addendum no. 03

Project: Skyway Resource Center Redevelopment
Renovation & Expansion

Schemata Project No.: 2052

Date: 13 November 2023

PLUMBING PLAN -
BELOW GRADE

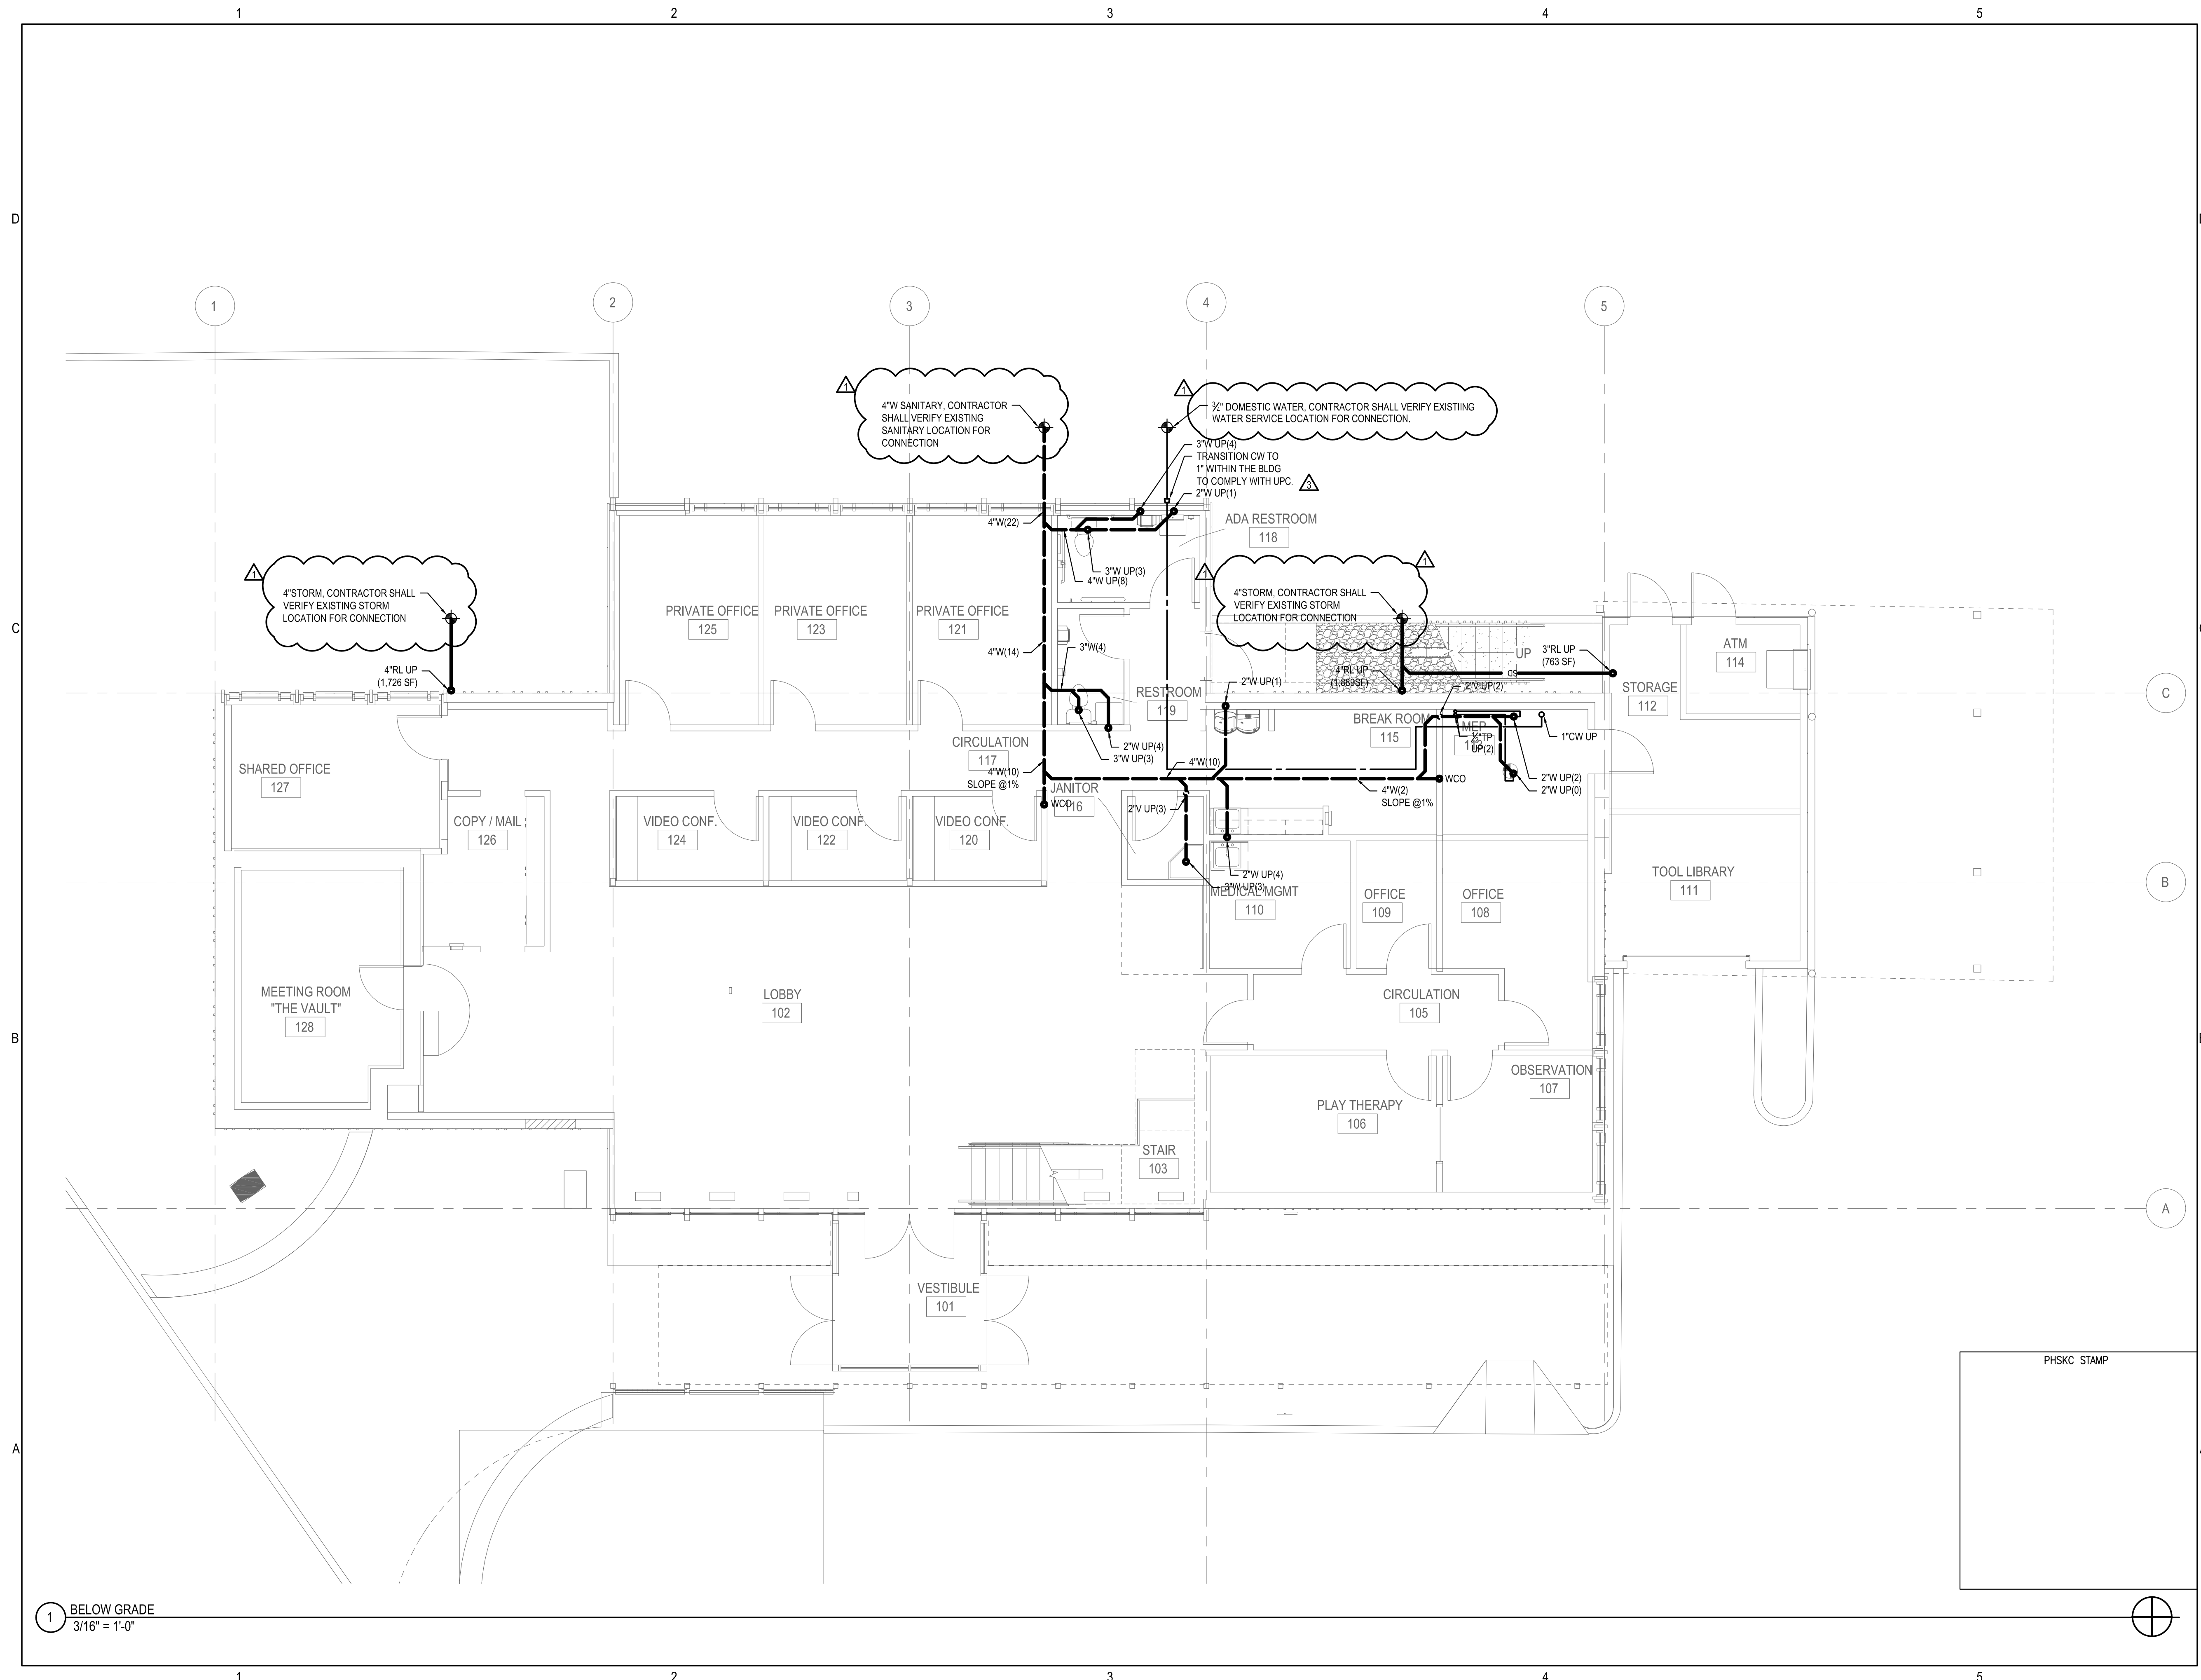
Replace drawing sheet P3.00 with the attached revised edition.

33. On P3.00, the page references Civil Drawings for the continuation of the storm, sanitary, and domestic water lines. The Civil Drawings were not included in the bid package. Please provide the referenced Civil Drawings.

Response: Reference to civil drawings has been removed from sheet P3.00. The plumbing lines shown on P3.00 will connect to existing lines outside the building. Coordination demolition of existing plumbing lines to allow for connection points indicated.
